VALVE ELECTRONIC

CV 2362
TO
CV 2368

Specification Mintech./CV2362 - CV2368 Issue 2A, Dated September 1967 To be read in conjunction with K1001 ignoring clauses:- 5.2, 5.3, 5.8.	SECURITY	
	Specification Unclassified	Valve Unclassified

AMENDMENT No.1

Page 5. Outline Drawing.

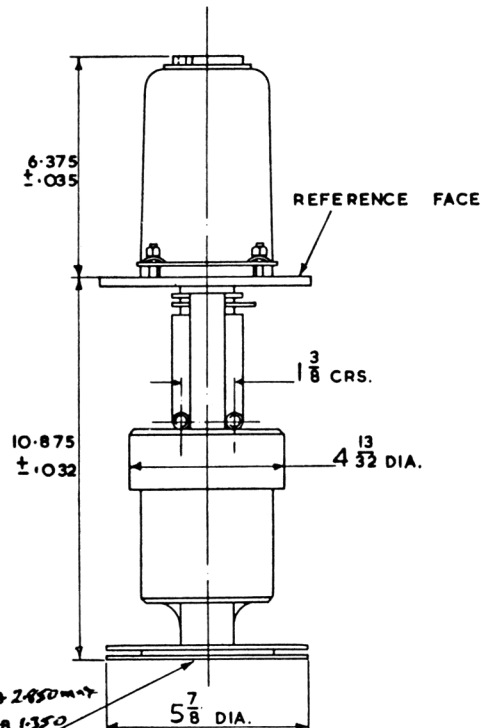
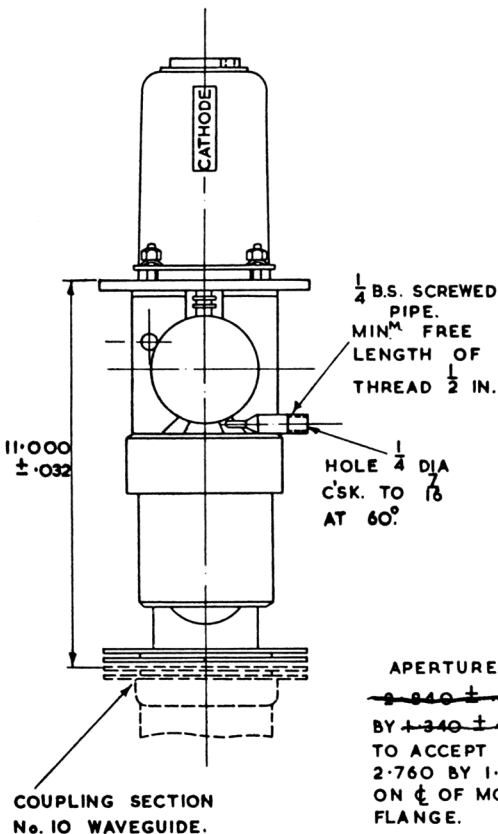
View in top right hand corner.

The flange diameter is shown as "6.000 Dia $^{+~.000}_{-~.000}$"

which should be amended to read "6.000 Dia $^{+~.000}_{-~.010}$".

PAGE 1   Text, headed 'Aperture' (bottom centre of page)

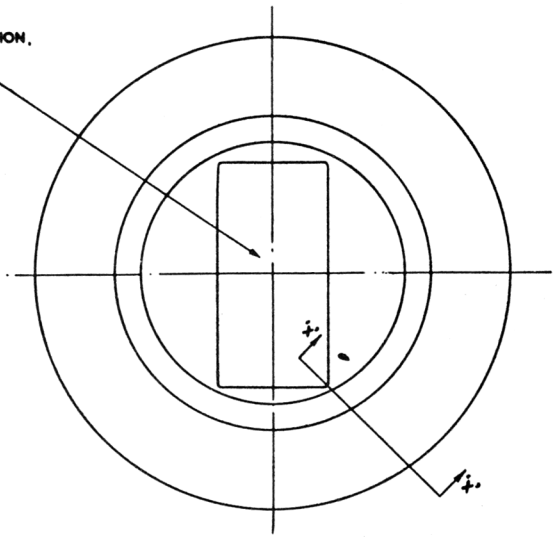
Delete the first two lines of the text "2.840 $\pm$ .008 by 1.340 $\pm$ .008" and insert "2.850 max by 1.350 max"

~~2·040 ± ·008~~ 2·050 m-t
BY ~~1·340 ± ·008~~ 1·350 m-t
TO ACCEPT PLUG
2·760 BY 1·260
